TUESDAY, NOVEMBER 18, 2014
(COUNCIL CHAMBERS)

1. "State of the Foundation" report from College Park Community Foundation (request of Councilmember Dennis) - Richard Morrison (Chair) and Dave Milligan (Vice Chair)
2. Preliminary Plan and Detailed Site Plan for The Hotel at the University of Maryland – Terry Schum, Director of Planning
3. Recommendation for award of Business Recycling Grant – Loree O'Hagan, City Recycling Coordinator
4. Proposed updates to the City's recycling code – Bob Stumpff, Director of Public Works
5. Discussion of Buy Local efforts – Councilmember Wojahn
6. Revisit the City's "Prohibited continuous parking in excess of 48 hours on public roadways" law - Councilmember Wojahn
7. Discussion of site selection for City Hall and discussion of acquiring a portion of the Stone Industrial site

SUBJECT: Preliminary Plan of Subdivision 4-14009
Detailed Site Plan (DSP) 14022
The Hotel at the University of Maryland

DETAILED SITE PLAN

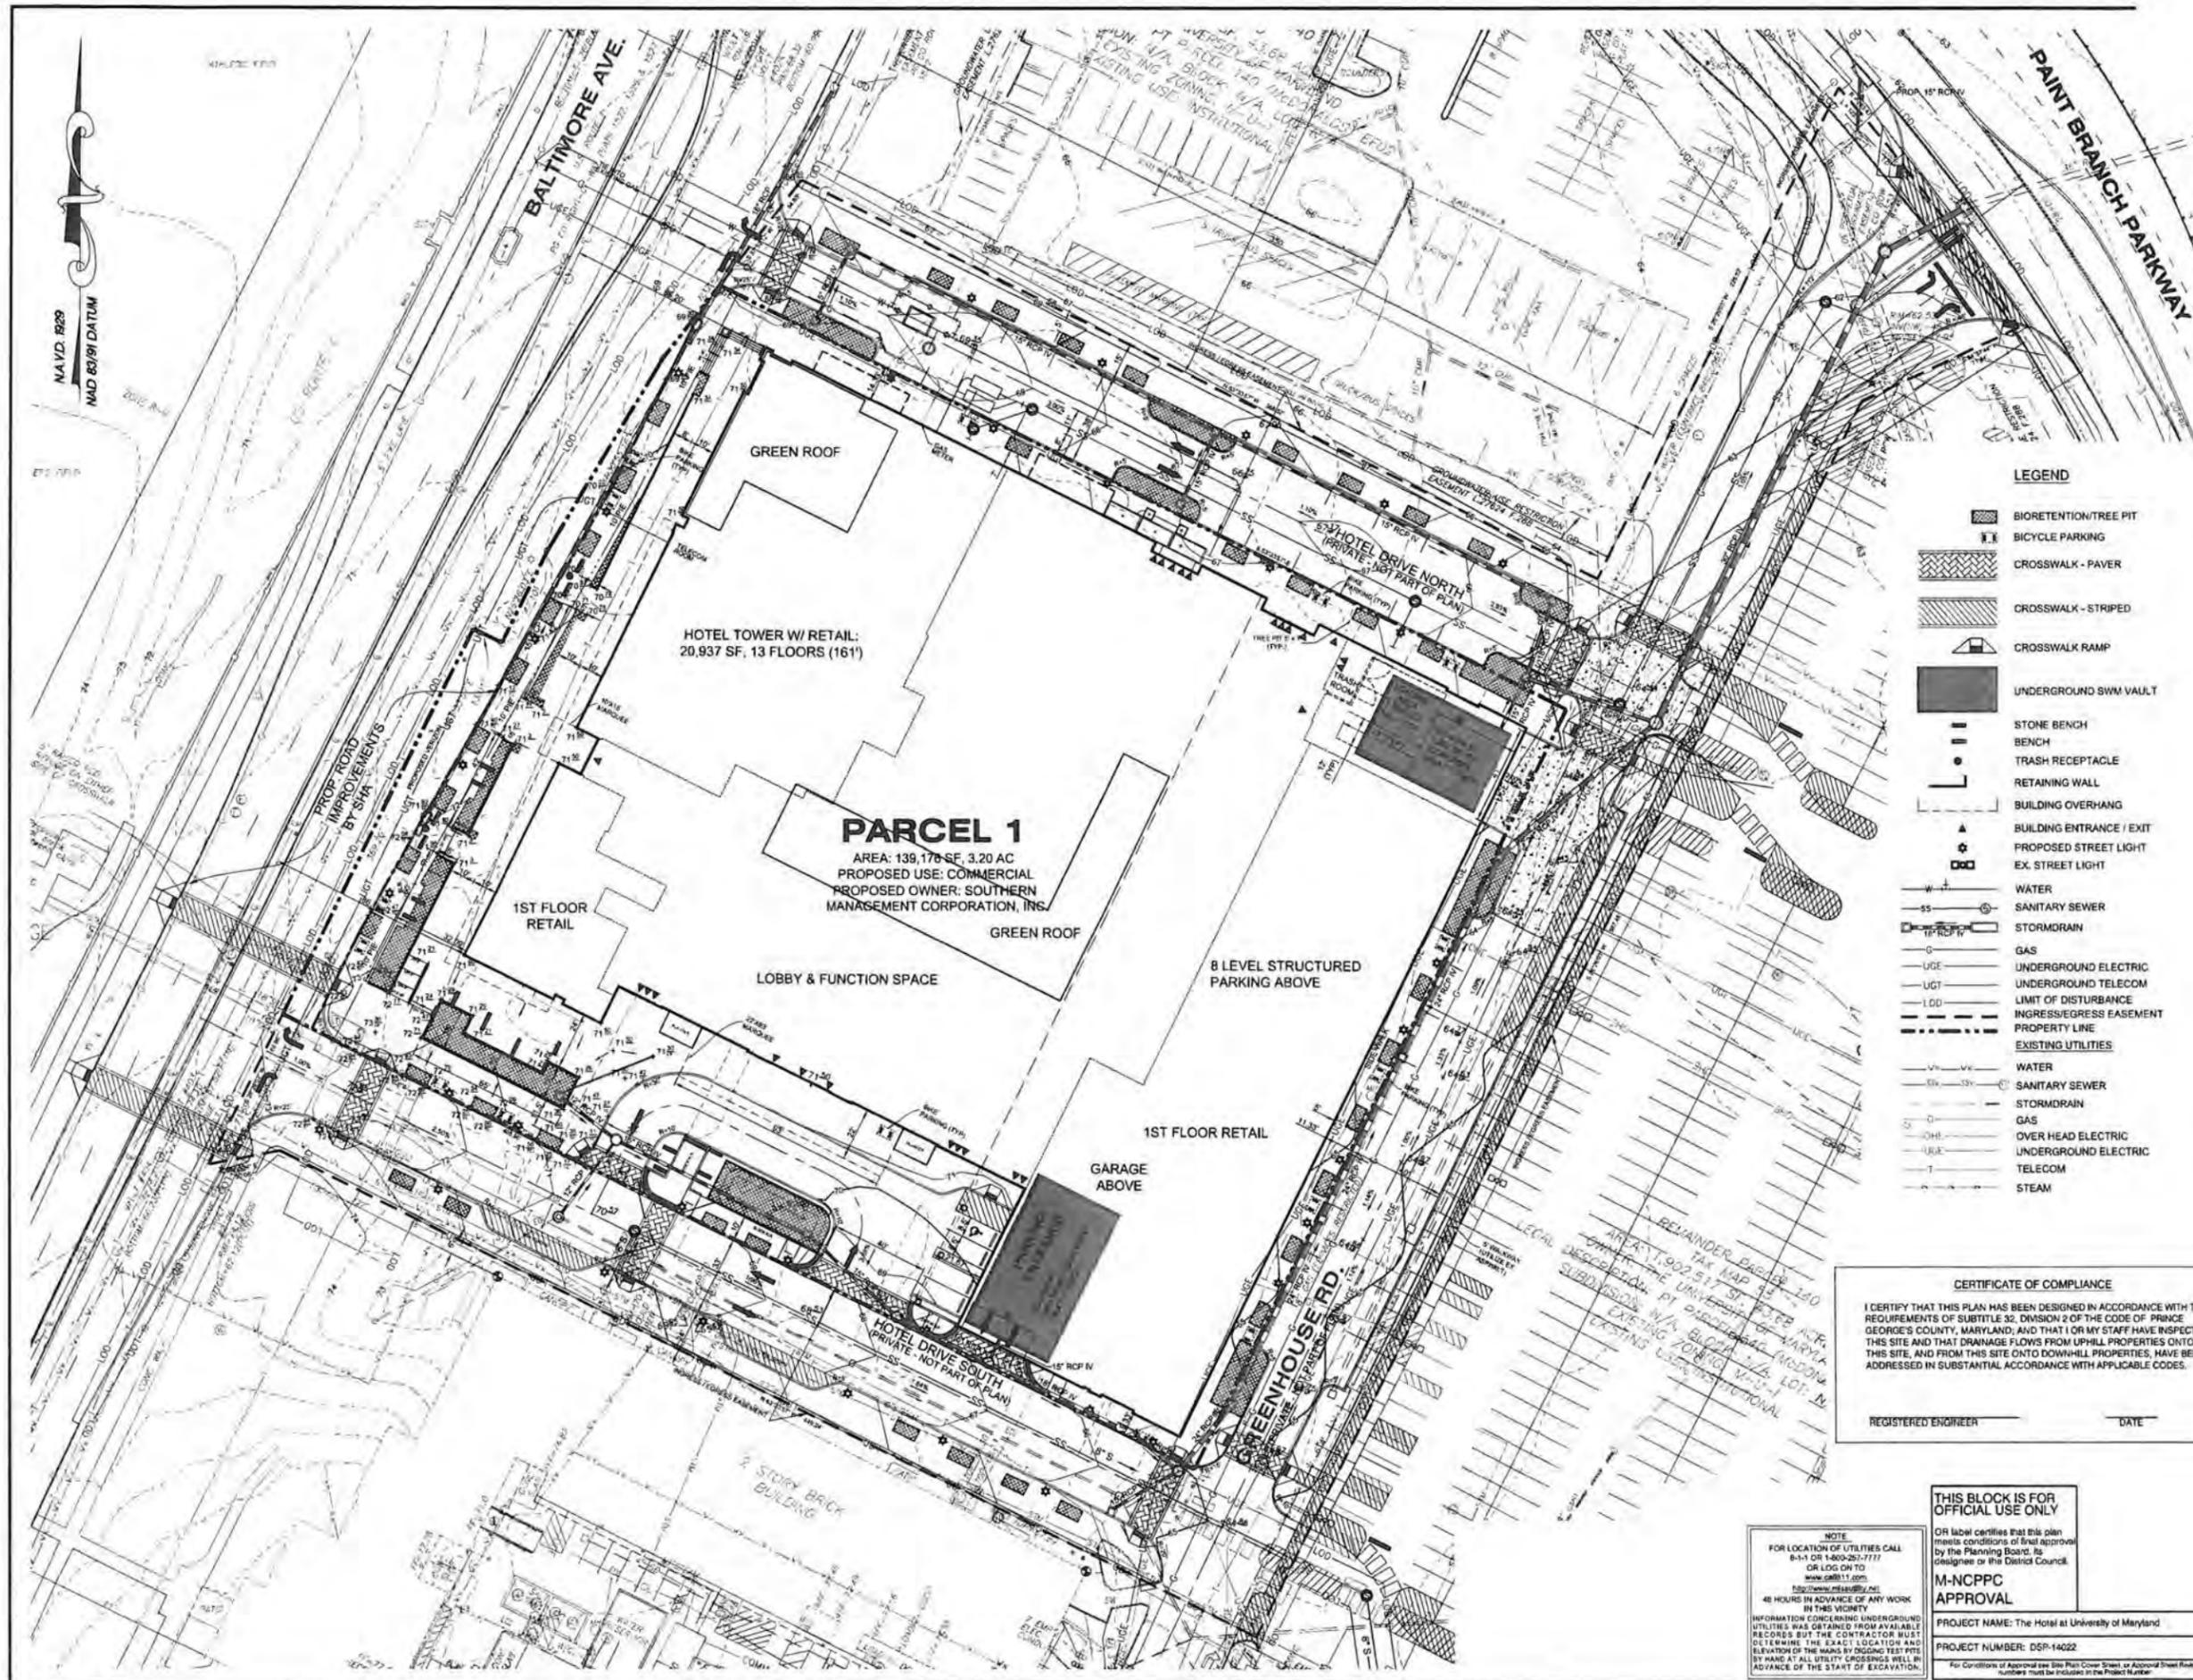
The Department of Permitting, Inspections and Enforcement (DPIE) notes that the proposed site plan is not consistent with the approved Stormwater Management Concept Plan No. 22605-2014. The proposed site plan does not include all environmental site design (ESD) practices or 100 year on-site attenuation storage shown on the approved concept plan. Submittal of final stormwater management computations will be required at the time of final site development

permits. These must demonstrate adequate storm water management and ESD volumes. The applicant has since revised his site plan (Attachment 3) to include underground vaults and all ESD facilities (including bio retention and green roof locations). City staff has included this as a condition.

4. Revise the Site Plan to :
 - a. Remove the crosswalk at the entrance to the hotel on Hotel Drive South or relocate to the east so as to more directly access the main entrance.

- b. Provide sidewalk access between the parking garage and on-site parking spaces.
5. Execution of an Agreement and Declaration of Covenants between the applicant, property owner and the City of College Park in the form substantially attached, including the following:
